In the Matter of AmerGen Energy Co., LLC

In the Matter of )  
 )  
AMERGEN ENERGY COMPANY, LLC )  
 )  
(License Renewal for the Oyster Creek )  
Nuclear Generating Station) )

**PREFILED SUR-REBUTTAL WRITTEN TESTIMONY OF  
DR. RUDOLF H. HAUSLER REGARDING  
CITIZENS' DRYWELL CONTENTION**

**Subject: Further Discussion of the External Corrosion  
on the Drywell Shell in the Sandbed Region.**

Figure 1

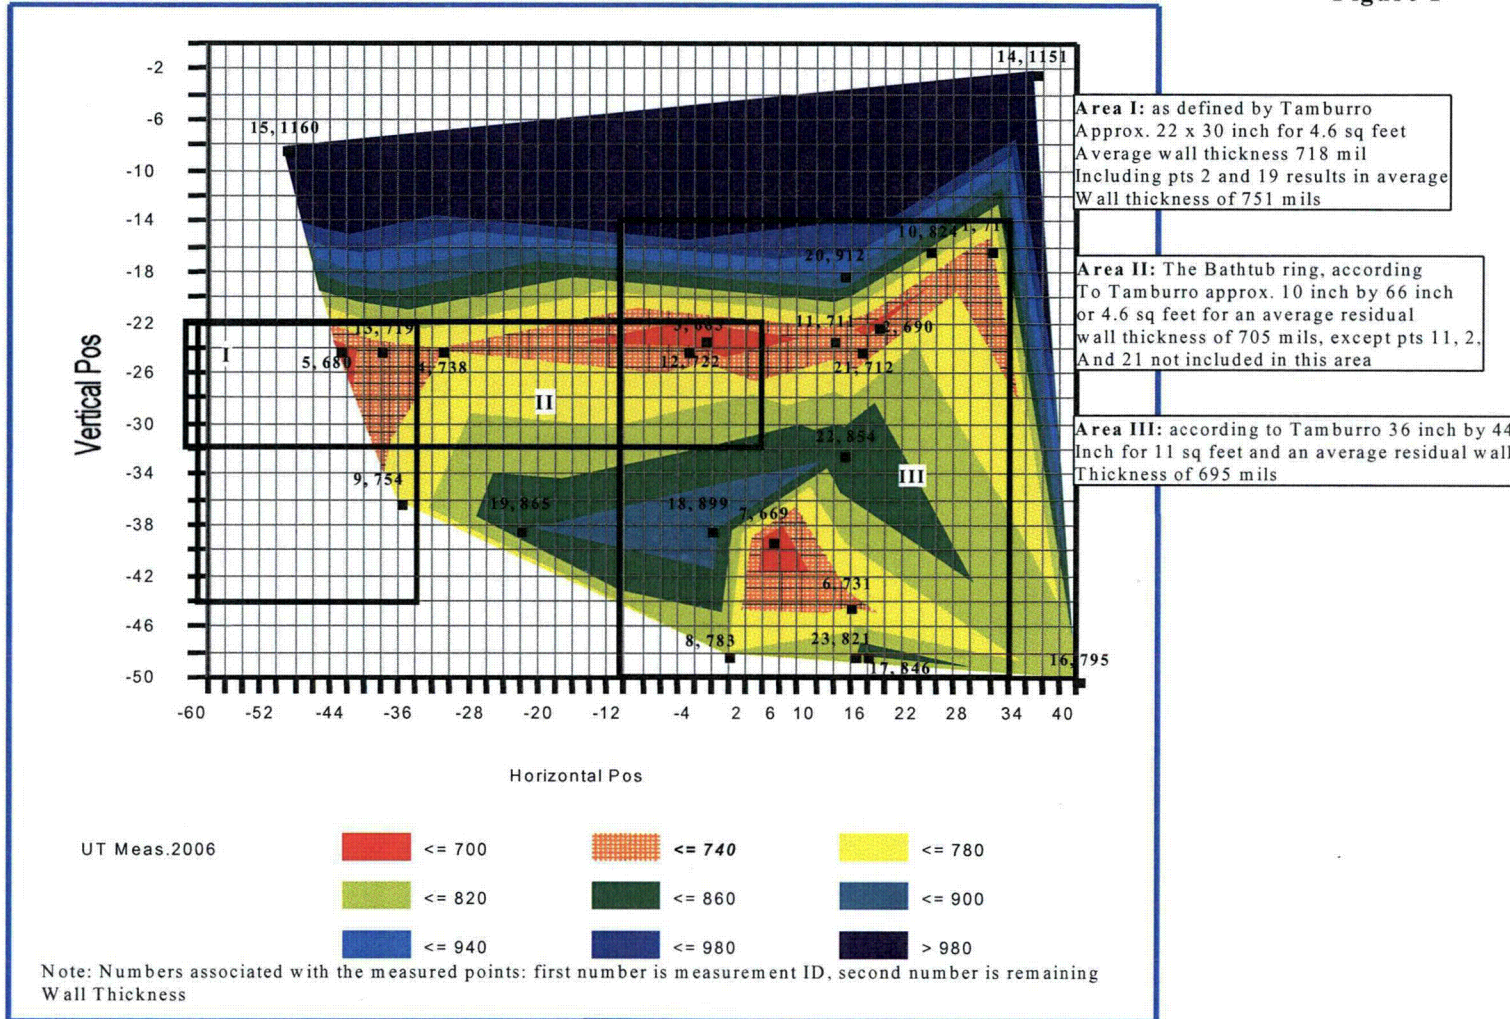
The resulting contour plot is shown in Figure 1. We have inserted the measurement ID's for each point as well as the respective remaining wall thicknesses. Additionally, we have superimposed Mr. Tamburro's evaluation, which is merely a coarse manual version of the contour plot.

Tamburro in Fig. 1-2 (Ref. 4) defines three areas as shown in Fig. 1 below for individual evaluation. Thus Area I contains points 5, 9 and 13 for an "average thickness of 718 mils in an area of 22 inch by approx. 30 inch, or 4.6 sq. feet. Strangely, in Fig 1-6 of Tamburro's work, the same area (referenced in Fig. 1-2) was narrowed and elongated to also contain points 4 and 19. The average residual thickness now was increased to 751 mils, while the estimated area was reduced to 23" by 16" or 2.6 square feet. Fig. 1 below, illustrates that the crude manual estimation by Tamburro is a coarse approximation to the surfaces generated by contouring. The advantage of using the computer is that the manual method is vulnerable to observer bias and does not provide an objective test of whether the results meet the local area acceptance criterion.

Next, Tamburro defines in Fig. 1-2 an area, which he dubs the "Bathtub Ring". Curiously, he does not include points 11, 2, and 21 in this area even though they are clearly part of the bathtub ring (see Fig. 1 below), but includes these points in another area, which we identified as area III in Fig. 1 below. But when this area (Area III in our Fig. 1) is discussed by Tamburro in his Fig 3-1 (page 30 Ref. 4) he is not consistent in the dimensions. Nevertheless, he identifies this area as the 736 mil boundary and inserts in the same graph a 636 mil boundary somewhat arbitrarily in the middle. Now, Tamburro has identified an area of 14 x 18 inches in his Fig 1-3 as having an average wall thickness of 696 mils (points 7, 11 and 21) and being 1.75 sqft in area. But curiously, point 6 (clearly a companion point to 7 and certainly part of a corroded area) is left out of this exercise.

The peculiar thing about this is that we have been accused of *using the wrong data the wrong way*. The contours are calculated by triangulating between all the points. Tamburro averages (a primitive form of triangulating) across a few points. Please note that point 7 is a good 16 inches removed from points 21, 11 and 2, with other measurements (point 22) in between. The contours indicate that there is not a straight-line slope between point 7 and the others as Tamburro assumes, but that there is in fact a "hump" over point 22. Consequently, the interpretation of the external UT measurements by means of the response surface methodology results in a less severe picture than the one Tamburro arrives at.

There are, however, other, more serious slights of hand in the Tamburro evaluation. In Fig 1-4 (Ref. 4 pg 31) he compares the area covered by points 2, 7, 11 and 21 to the local buckling criterion. He tells us that the area covered by these points is 7 inch by 4 inch or only 0.2 sq feet, when it can easily be seen from our Fig 1 below that the

area attributed to these points would be of the order of 18 by 14 inches or nearly 2 sq feet. Figure 1-4 is therefore incorrect. The same error is repeated in Tamburro's Fig 1-5.

And when it comes to the bathtub ring (Fig. 1-6) and an assessment of points 5, 13, and 4 he conveniently adds points 9 and 19 (see Fig. 1 below) to arrive at an average wall thickness of 751 mils. There is no obvious justification for including point 19 in the bathtub ring. Without it the average would have been 722 mils over an area of about 14 by 14 inches or 1.4 sq ft.

When all is said and done, Tamburro rearranges the data again in Fig. 1-7 and finds an area of 9 sq feet that has a residual wall thickness of 696. However, as clearly shown on Figure 1 this Fig. 1-7 is again incorrect because the area selected must actually be at least 42 inches by 36 inches to capture all the points show on Fig. 1-7, which is considerably larger than 9 square feet.

Figure 2

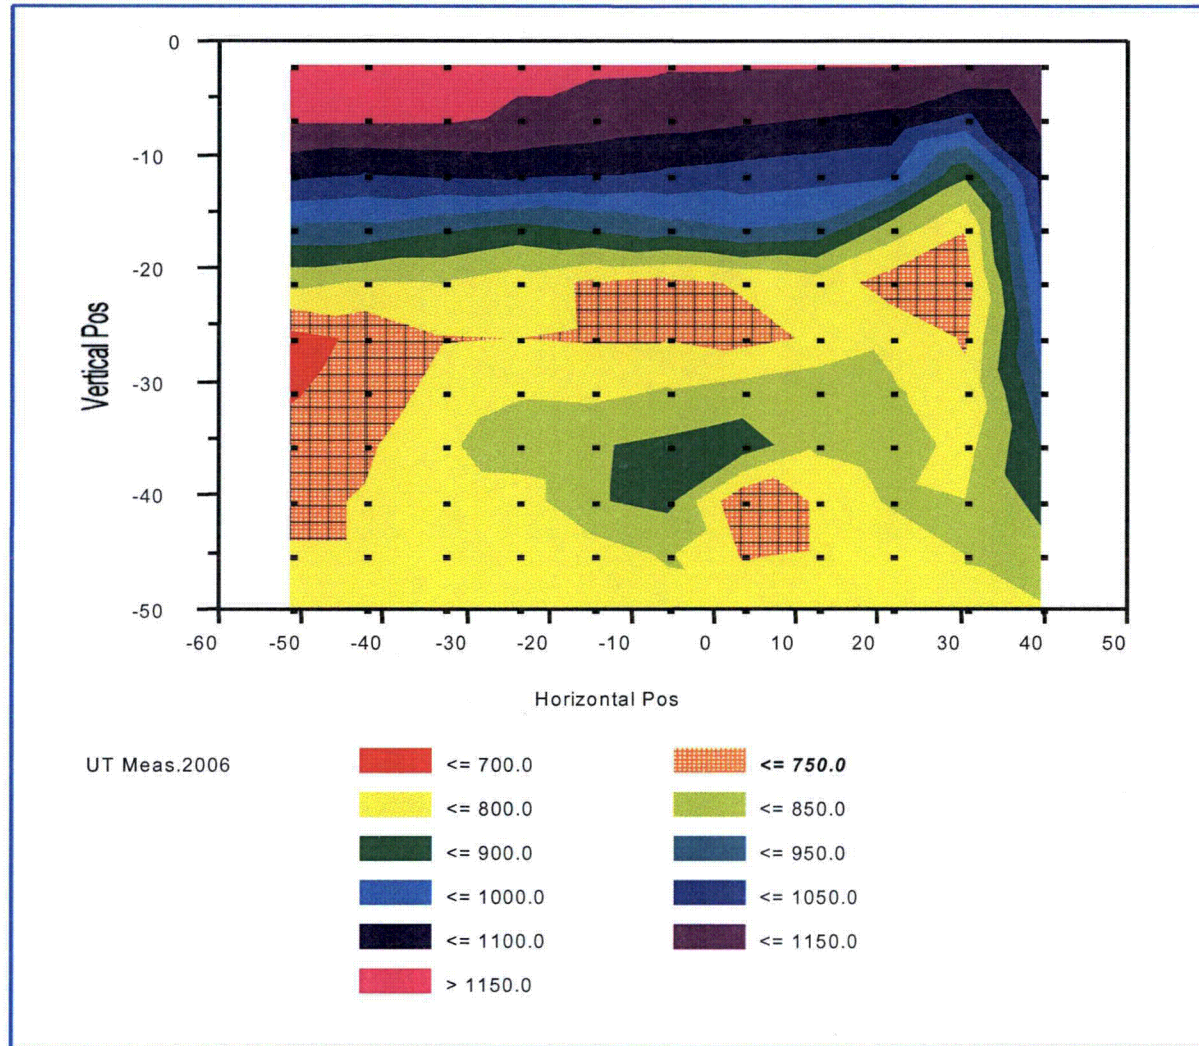
The triangulation, on the basis of which the response surfaces are generated, first generates the equations (correlation functions) used to draw the contours. These same equations can then also be used to define a grid larger than the area that had actually been covered by measurements, and to extend the contours for the purpose of predicting, in this case, the extent of corrosion one might expect outside the measured areas. This was done in Figure 2 below for Bay 1. The reason why this was done was because it was suspected that the bathtub ring might extend away from the vent line into the center of the bay. Indeed, as can be seen from Figure 2, a large area of about 15 by 20 inches might exist with a residual wall thickness of less than 750 mils and might actually extend into Bay 19. This is a prediction based on the existing data, and if verification of this prediction is outside the scope of the present intervention, it is certainly a better prediction than the assumption that corrosion stopped with the evaluation of points 5 (680 mils), and 9 (745 mils) 30 to 35 inches below the top of the sandbed.

We also see from Figures 1 and 2 that at the top of the sandbed essentially no corrosion occurred. This is in agreement with the internal grid measurements which essentially showed the same thing, **and which is in part the reason why we have concluded earlier that the internal grid measurements do not reflect the corrosion in the sand bed area and are not in anyway representative of the corrosion of the drywell liner.**

**Figure 3**

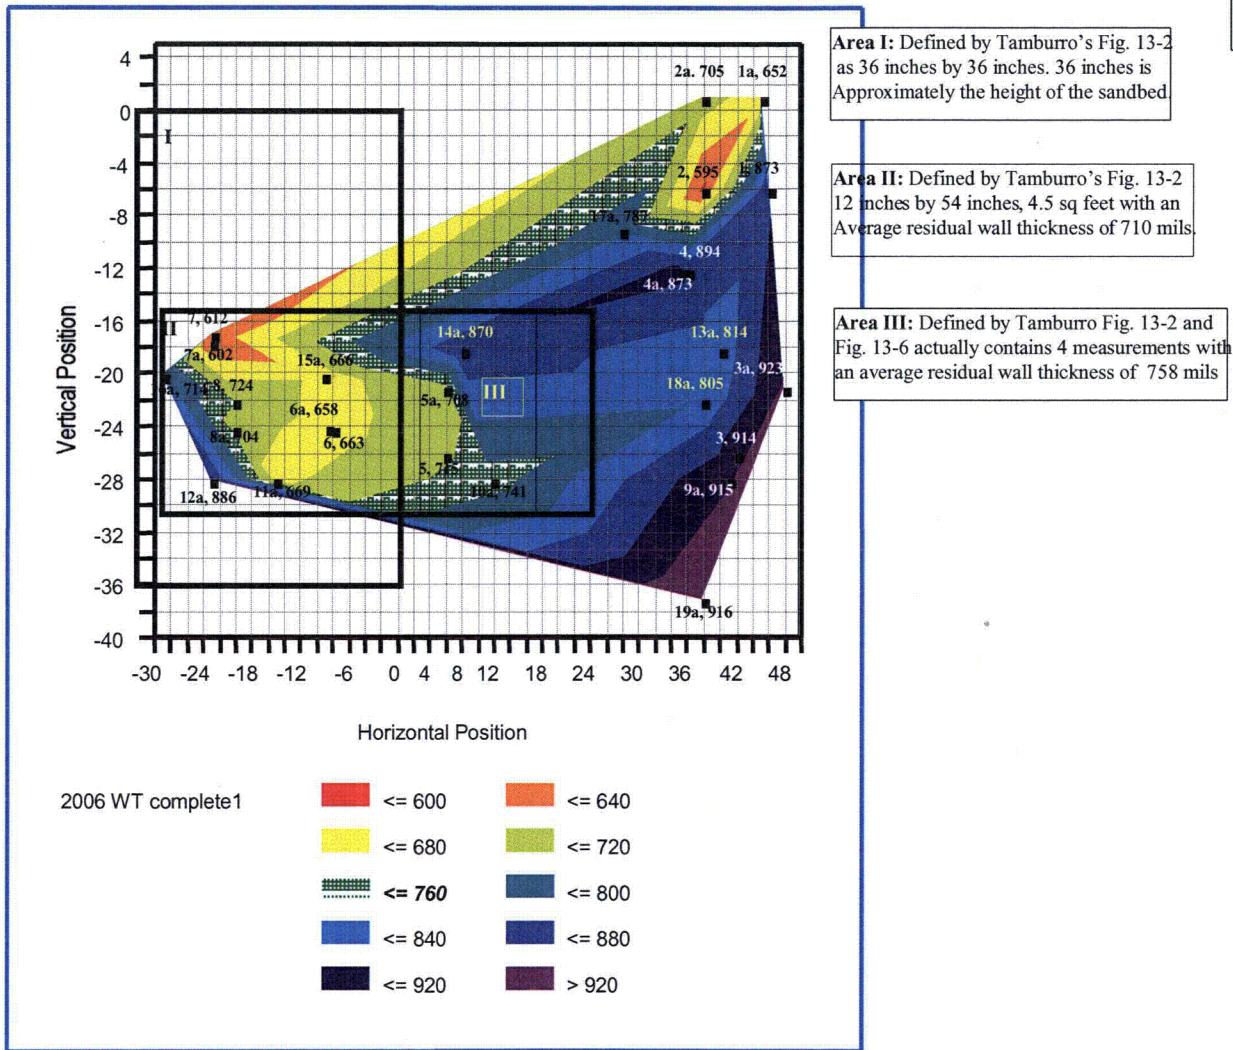
Figure 3 below thus shows the response surface for the 2006 external UT measurements in the sandbed region. Superimposed are the three areas, I, II, and III, which Tamburro proposed in order to analyze Bay 13 corrosion in greater detail. Tamburro locates all measured points in an approximate graph of Figure 13-1 on page 63 of Ref. 4. It is noted first of all that the relative position of the individual points is distorted when compared to Fig. 3 below which is drawn with the accurate coordinates. Second, as one looks at the numbering of the points it is hard to believe that an argument could be made that the points to be measured **had not been selected at random**. Finally, we also notice that all measuring locations are indicated in Fig. 13-1, however, as we proceed to examine Tamburro’s individual areas we find that for some unexplained reasons some of the most corroded points are left out. Thus within the three areas Tamburro proposes to discuss in Fig. 13-2 we find that points 1 and 2 and 1a and 2a are missing. Clearly, the absence of these heavily corroded areas from Tamburro’s analysis grossly distort his conclusions.

Tamburro and AmerGen have insisted all through these discussions that the most heavily corroded areas had been selected for UT measurements, and that their evaluation were conservative. However, in the final analysis the most heavily corroded areas are simply overlooked. It turns out that the bathtub ring in Bay 13 is not horizontal, but tilted toward the center of the bay.

**Figure 4**

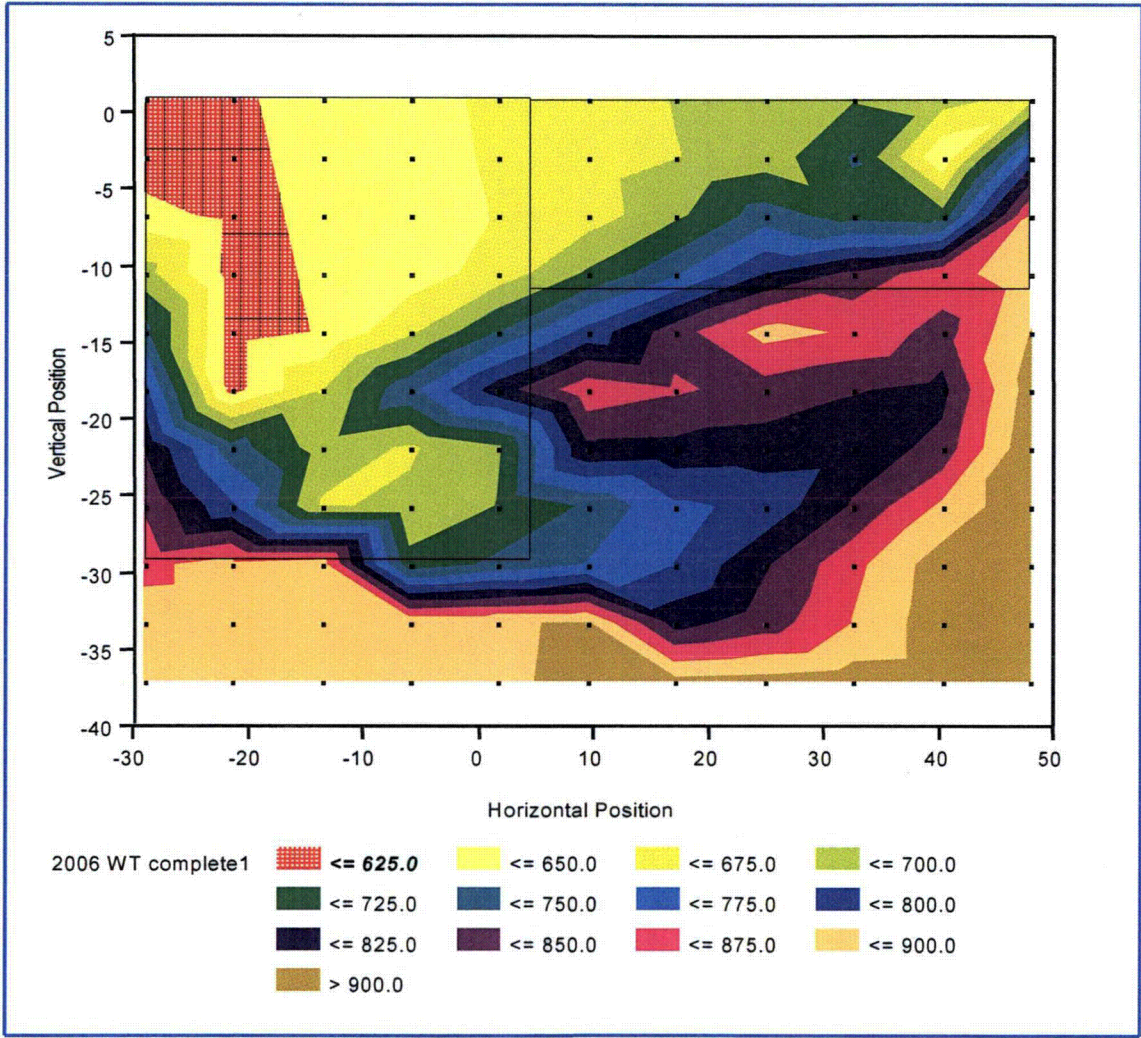
Figure 4 shows the predictive contours derived from the triangulation correlations. Note, that the areas predicted to have less the a residual wall thickness of 750 mils (dark green shading) extend all the way up to 0 on the scale of vertical coordinates, a few inches below the “internal grid measurements.” Three internal grids had been measured in this Bay (Ref. 11, Section 6, Table 6) with average residual wall thicknesses of 846 (13A). 904 (13D bottom), 1047 (13 B top) and 1142 (13 C). Thus, it is likely that the internal measurements are mostly above the angled bathtub ring, which is tapering out at 11’3” or thereabouts. **Clearly, however, none of the Internal Grid UT measurements reflects the severity of the actual corrosion in the sandbed area below 11’3” in Bay 13.**
